Your suggestions and comments are important to the US Highway 16 Neighborhood Area Future Land Use planning process. Please feel free to provide any comments you wish to make regarding the Plan. Please hand in this sheet before you leave the open house or send written comments by September 30, 2004 to: Patsy Horton, Rapid City Growth Management Department, 300 Sixth Street, Rapid City, SD 57701. Thank you for your help.

04CA032

US Highway 16 Corridor Study Future Land Use Map

PROPOSED REALIGNMENT OF SAMMIS TRAIL

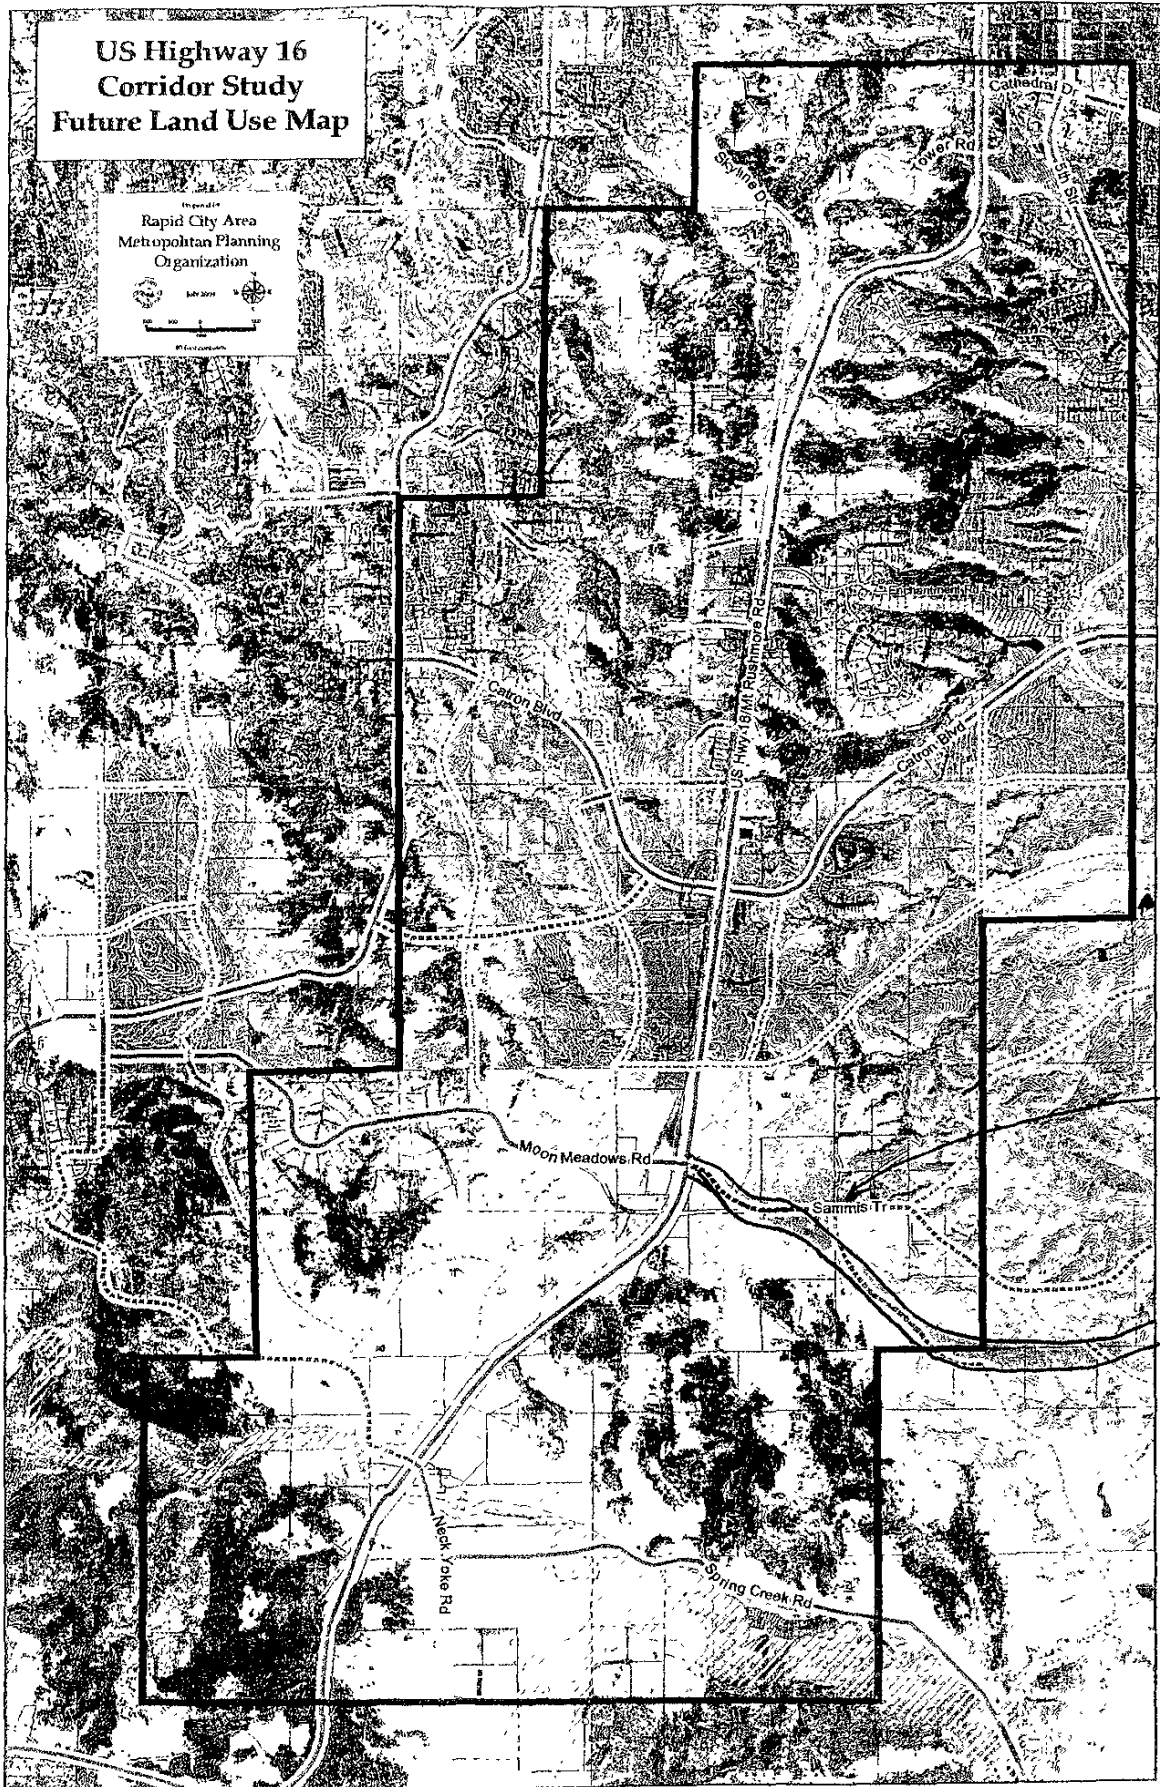
- C. There is undeveloped land that can be used to correct problems with the Right of Way for Sammis Trail and the 90° intersection of the Spring Creek connector at the Hyland Park proposed development. This 90° intersection is a very difficult transition for this traffic onto Sammis Trail, especially when at peak hours there could be the possibility of 3,000 cars per hour!

We suggest that this road go from Sammis Trail at a smooth angle through the proposed development at its West boundary to the section line/base line at the south end. This will provide better access to the property east, eliminate the 90° intersection, and avoid property disputes in the future. (See our map of proposed traffic changes given to Marcia Elkins.)

*Eliminate
the 90°
Intersections*
